NSD-NRC-97-5152
DCP/NRC0885
Docket No.: STN-52-003

SUBJECT: AP600 DESIGN CHANGES TO ADDRESS POST 72-HOUR ACTIONS

The SSAR markups in Attachments 1 and 3 will be incorporated in Revision 13 to the AP600 SSAR.

SSAR MARKUP INDICATING ADDITIONAL CHANGES
TO THE PASSIVE CONTAINMENT COOLING SYSTEM

Figure 1.2-2

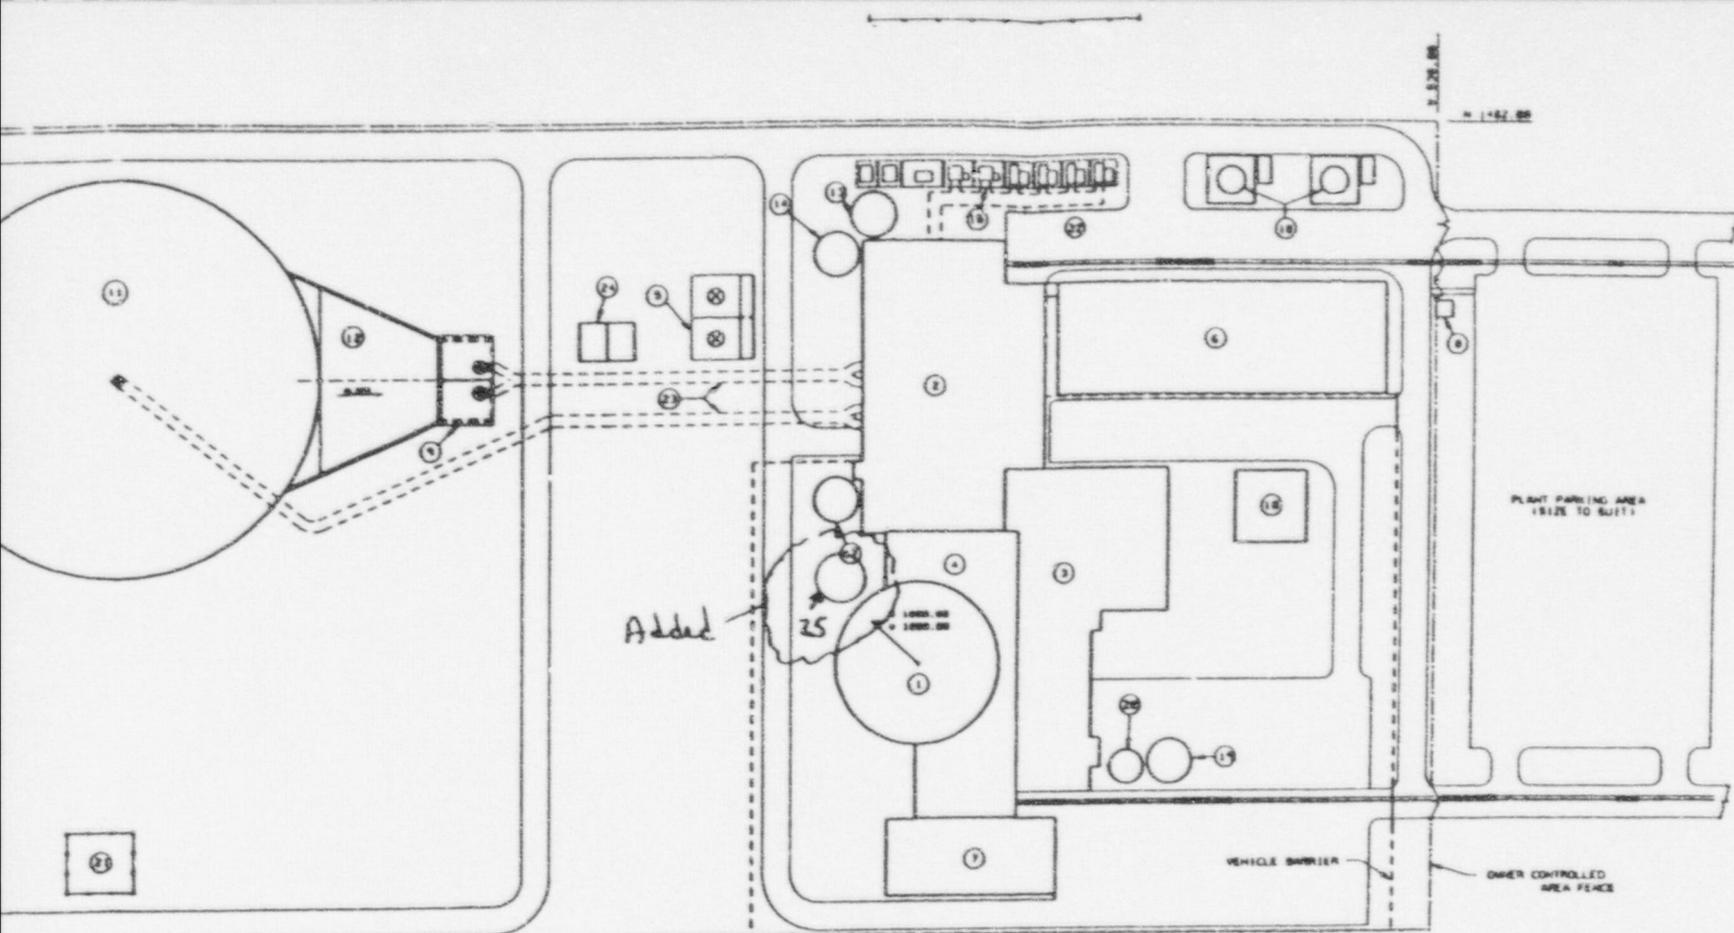
25. Passive Containment Cooling Ancillary Water Storage Tank

Figure 6.2.2-2

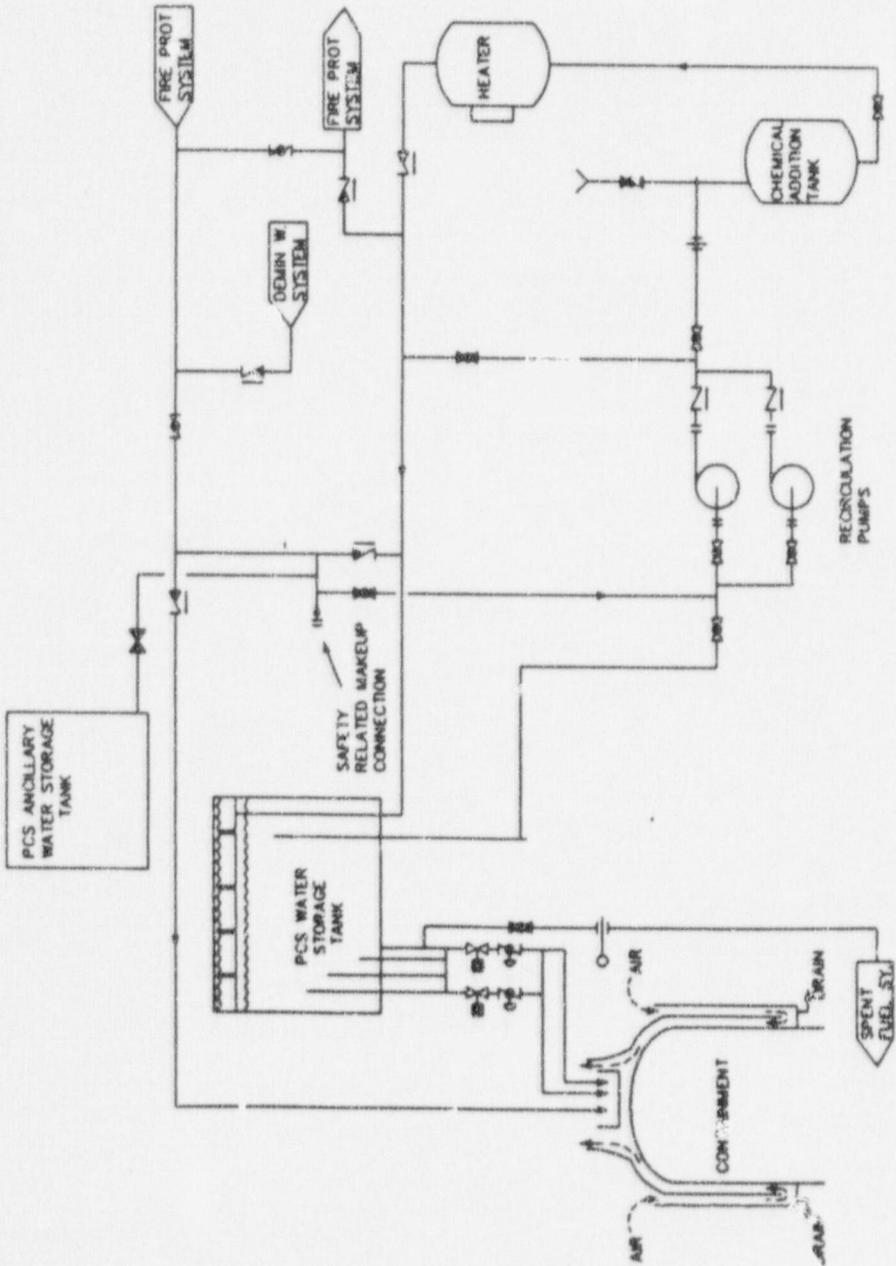
Replace with next page

Figure 6.2.1.1-5

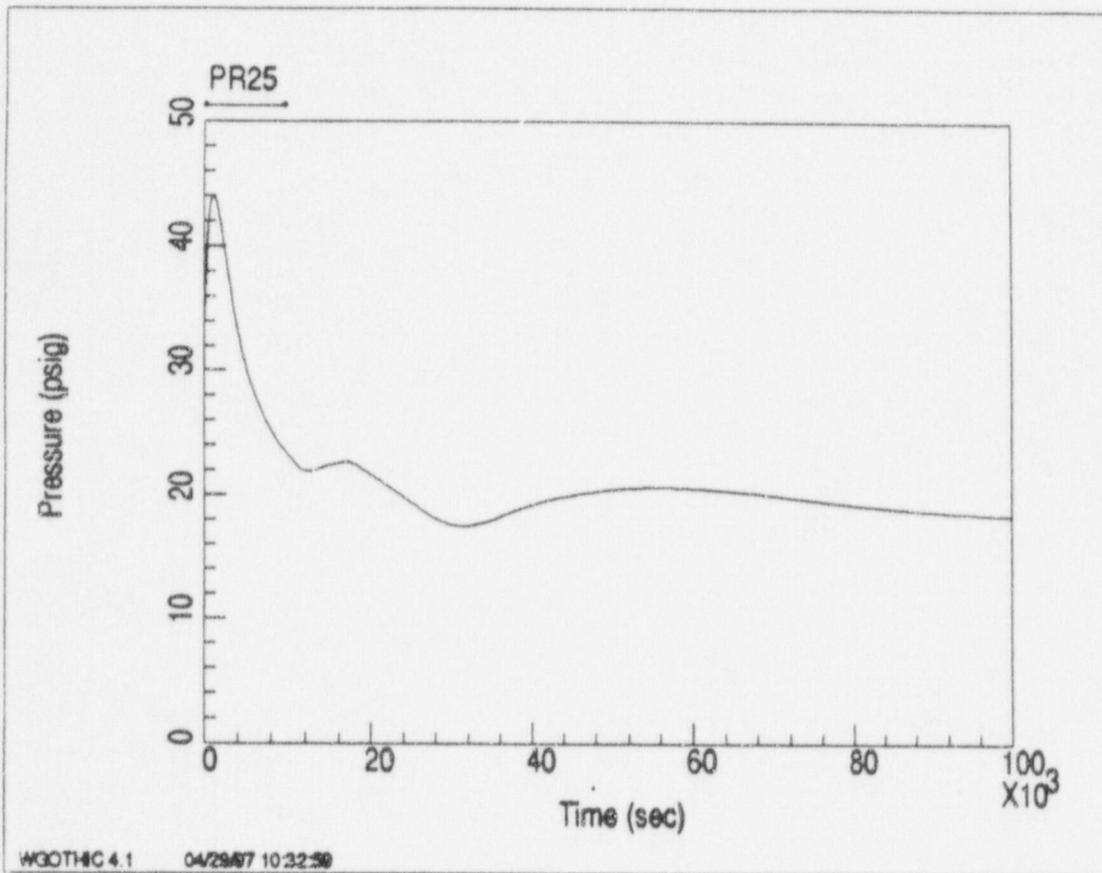
REVISED SSAR FIGURES INDICATING THE
RESULTS OF THE REVISED WGOthic
CONTAINMENT PRESSURE ANALYSES.
